PRELIMINARY SAFETY AND ENVIRONMENTAL INFORMATION DOCUMENT

VOLUME V

GAS-COOLED FAST REACTORS

January 1980

Figure B-1. GCFR six-loop PCRV. Loop arrangement with top exhaust steam generator.

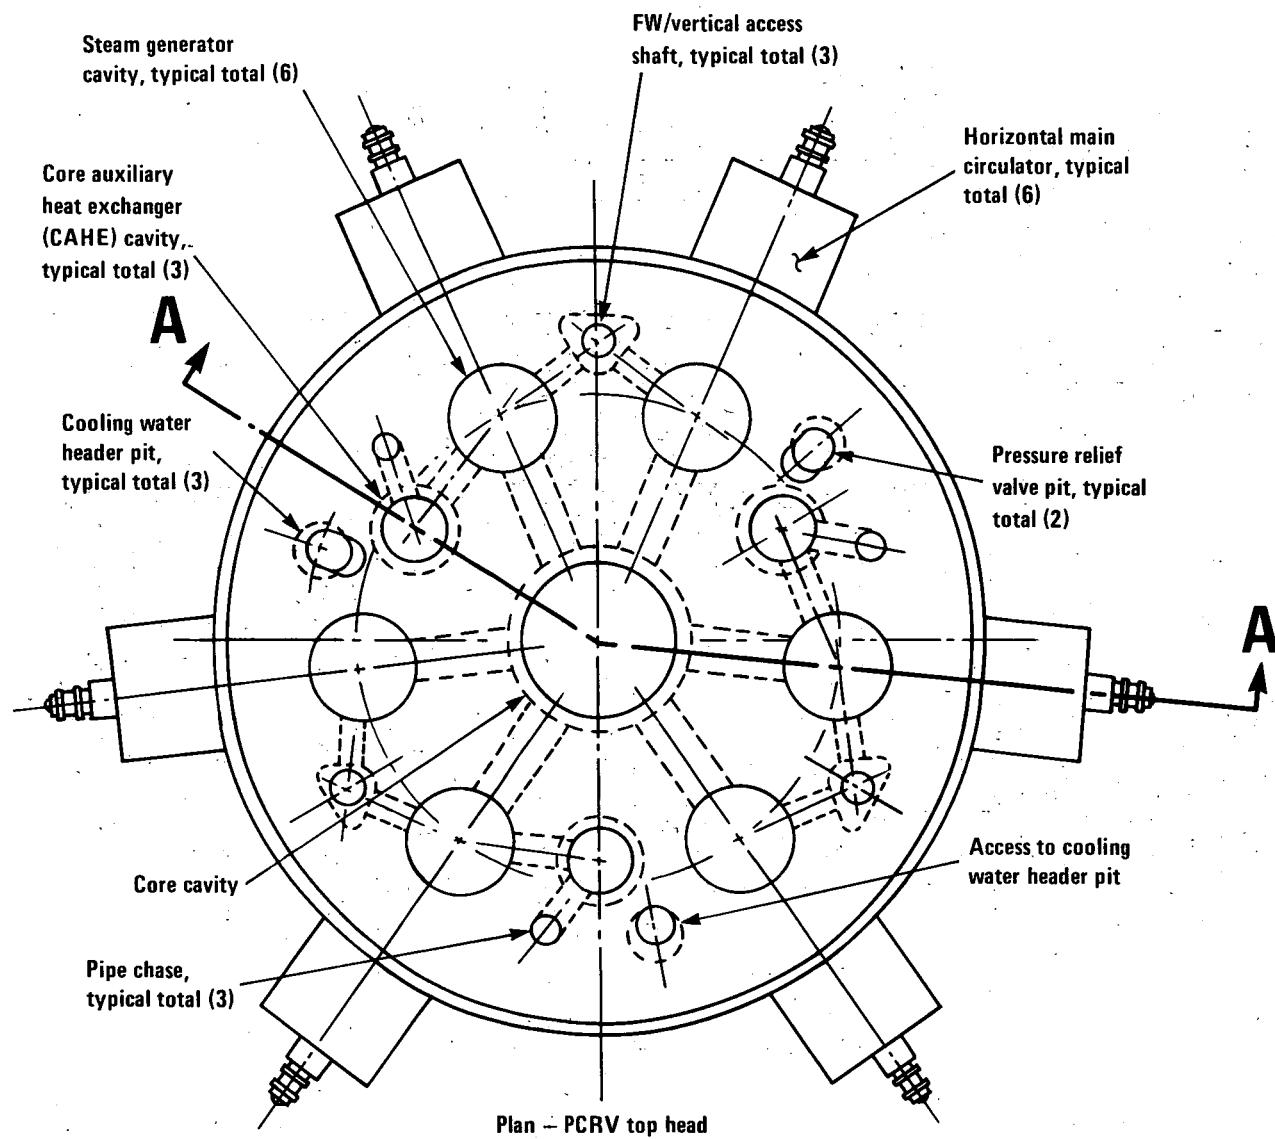
In the event that the upflow core-cooling design is adopted for the gas-cooled fast-breeder reactor (GCFR), it will be necessary for the U.S. Department of Energy (DOE) to re-describe the principal design features of the GCFR and provide an assessment of its safety characteristics in the prevention and mitigation of postulated accidents. This documentation should address all 13 of the safety considerations given on page 2-21 (page 2-20 of this volume) of the preliminary safety and environmental information document (PSEID), provide discussion of any additional safety considerations that the DOE considers necessary and appropriate, and address all of the comments and questions contained herein in the context of the upflow design. We foresee that the upflow design would not adversely affect our general conclusion given in the 1974 Preapplication Safety Evaluation Report and that some of our conditions and reservations regarding the adequacy of the present emergency core-cooling provisions might be positively addressed. Criteria related to the adequacy of thermal margins and fuel damage in the case of natural convection cooling would have to be developed in connection with the assessment of the adequacy of the use of natural convection for emergency core cooling.

The PCRV configuration for a 1,200-MWe plant and the arrangement of the components in the six primary and three auxiliary coolant loops are shown in Figures B-1 and B-2. The central cavity contains the reactor core and shielding and is sealed by a concrete closure. The coolant flow for a primary loop (Figure B-2) is upward through the core into the core outlet plenum, then through the hot-gas duct to the steam generator cavity. From here the coolant flows downward across the steam generator tube bundles to the main helium circulator that pumps the helium to the core inlet plenum at the bottom of the central cavity. The helium circulators are located in horizontal penetrations in the bottom head of the PCRV.
